**Proposal  
for  
modification  
of  
the satellite boxes**

# Synopsis

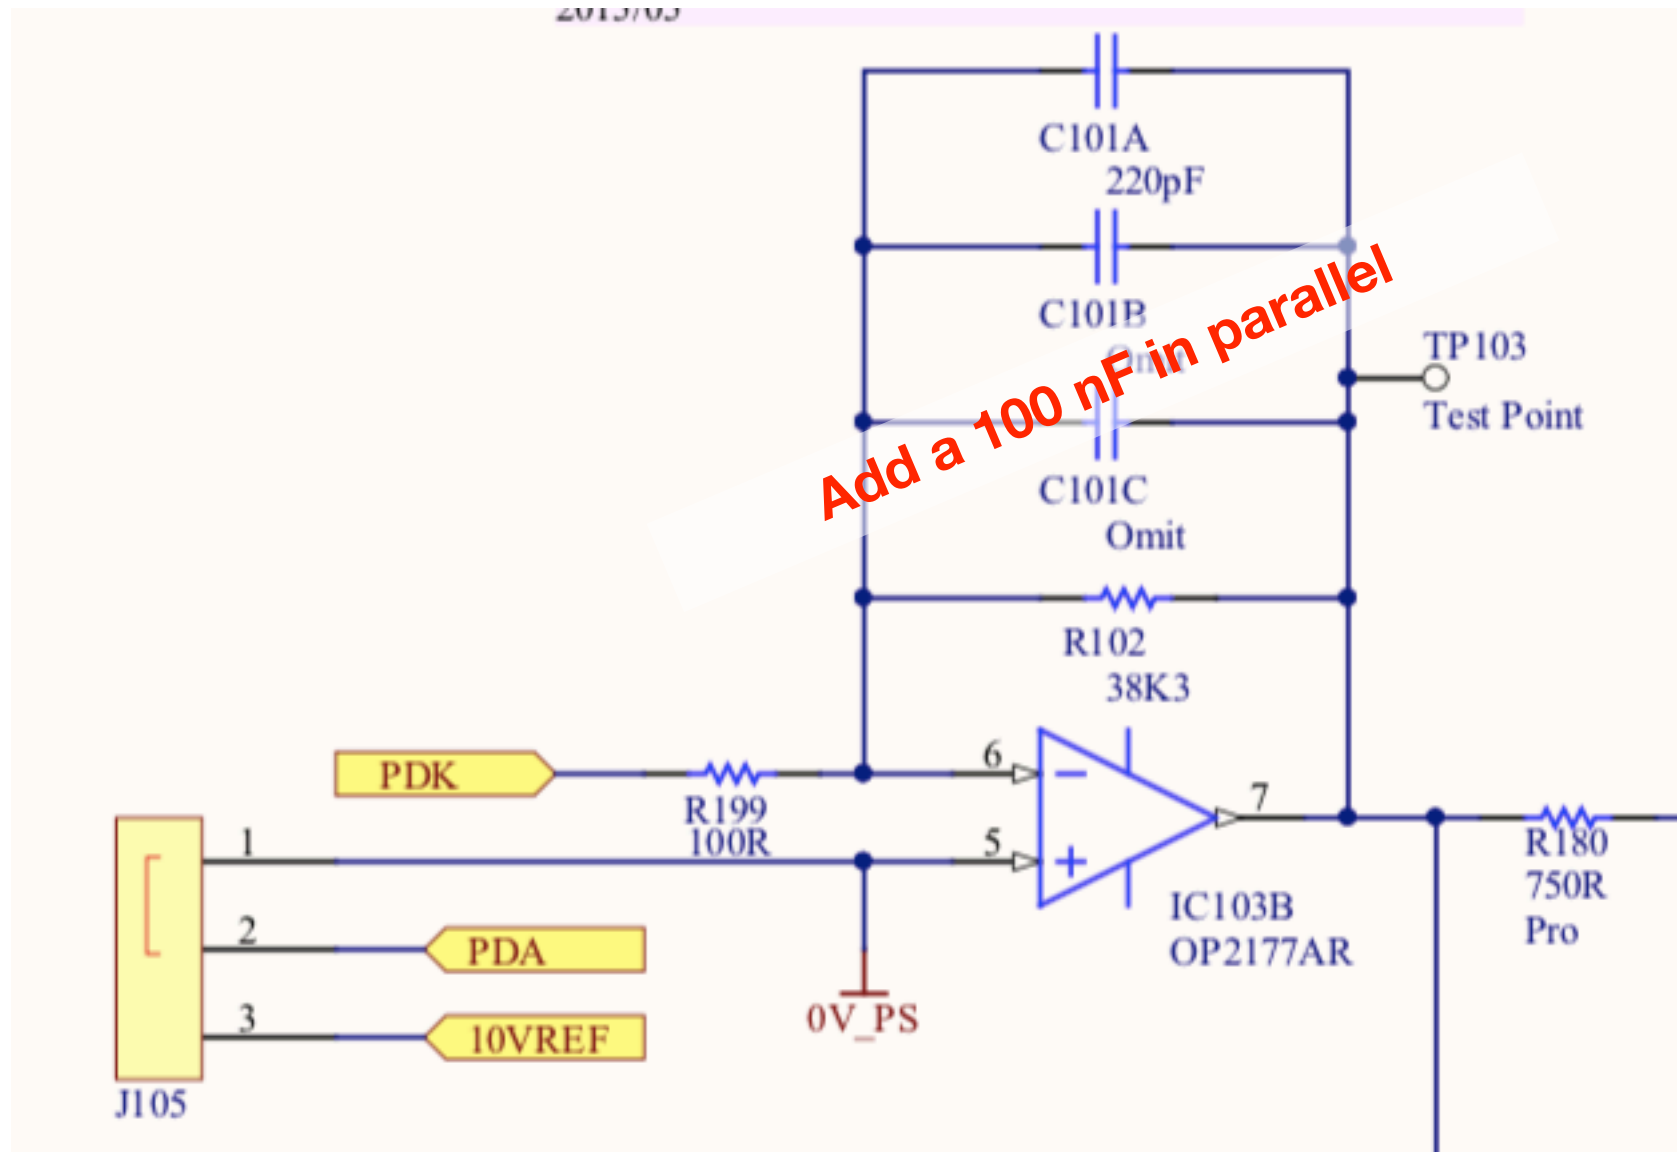
- ✓ The op-amp in the first stage of the sat. box occasionally doesn't properly operate (depending on the cable load). This leads to some high-freq. oscillation.
- ✓ Let's add **a 100 nF cap.** in parallel to the op-amp feedback resistor and do this modification for all the satellite boxes.

✓ The signal bandwidth will be limited to ***41 Hz.***

- ✓ The bandwidth was originally designed to be **19 kHz** which seems too high for most of our applications.
- ✓ Akutsu et al. some years ago found that an additional capacitor stabilized the op-amp while this mod. reduced the signal bandwidth at the same time.
- ✓ To date, several of us tested/implemented a few capacitor values, 10 nF, 100 nF and 470 nF (although in different setups). All worked out fine so far.
- ✓ CRY group prefers **100 nF (41 Hz)**. VIS and AOS implemented **470 nF (9 Hz)** to a few places.
- ✓ AEL group prefers ***one capacitor value for minimizing their working effort.***
- ✓ ***The 41 Hz bandwidth should cover the signal bandwidth required for CRY, VIS and AOS*** while still preventing the op-amp from oscillation.
